Board Staff Interrogatories

Licence Amendment Application Exemptions from Distribution System Code

**Hydro One Networks Inc.
EB-2010-0229**

**DSC REQUESTED AMENDMENTS IN REGARD TO UNFORESEEN
TECHNICAL ISSUES WITH RENEWABLE ENERGY GENERATION
PROJECTS**

DG Influence on Feeder Voltage Profiles during light loads

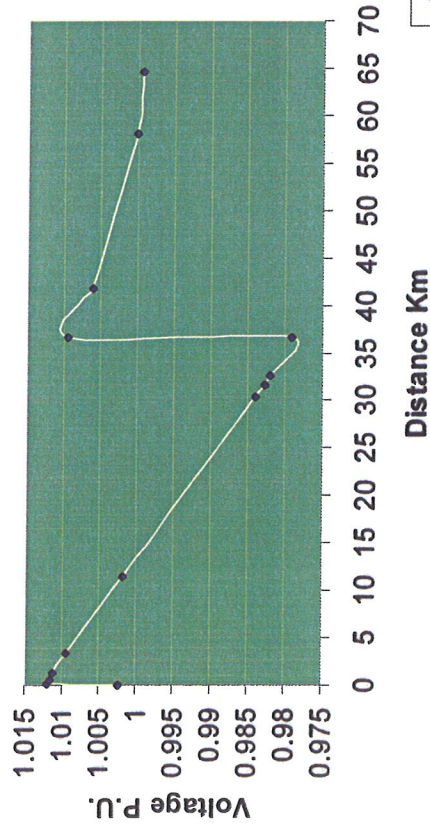
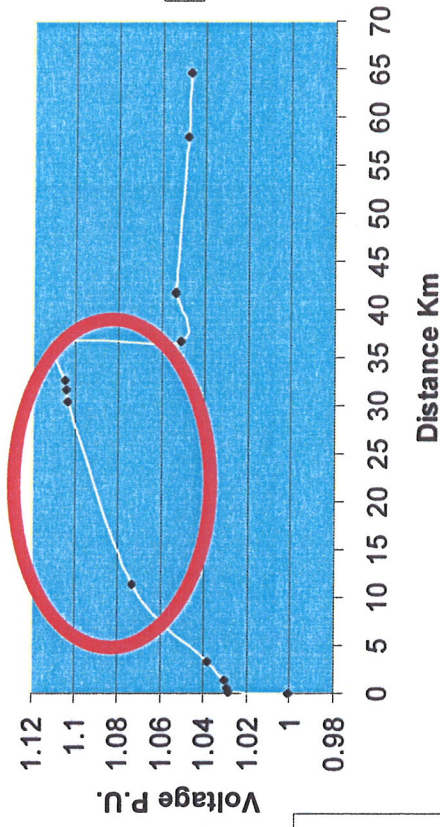
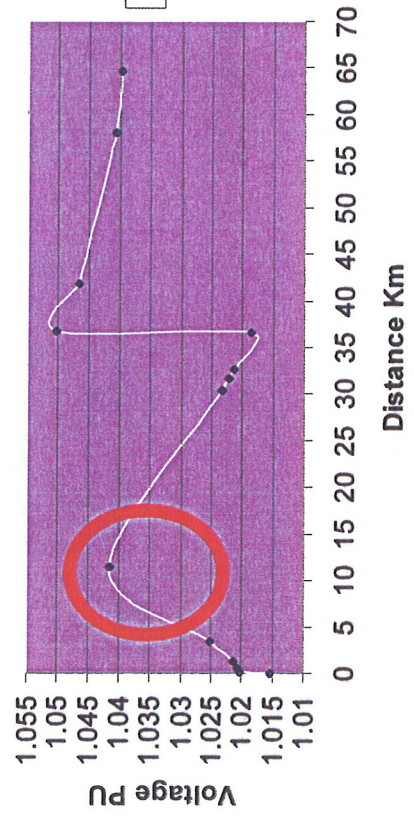
- In Reference (b), the evidence seems to indicate that Hydro One Distribution was aware of the implications of connecting distributed generation including voltage management under various conditions. For instance on page 8 of Reference (b), the illustrative graph shows the voltage variation profiles of three scenarios – No Gen, Max Gen @ Max Load, and Max Gen @ Min Load. Page 9 depicts the voltage profile (variation) for three cases – for a case “Without DG”, for a case with “2 X 9MW DGs near TS” and a third case with “Full DG penetration”.

- (i) In light of the Hydro One Presentation depicted in Reference (b), and the experience gained from connection of run-of-the-river hydraulic generation to the distribution system, please explain why Hydro One indicates in Reference (a) that it has not experienced the excessive voltage fluctuation problem in the case of generators connecting at a distance from the station (“distance limitations”), and why this problem could not have been reasonably foreseen.
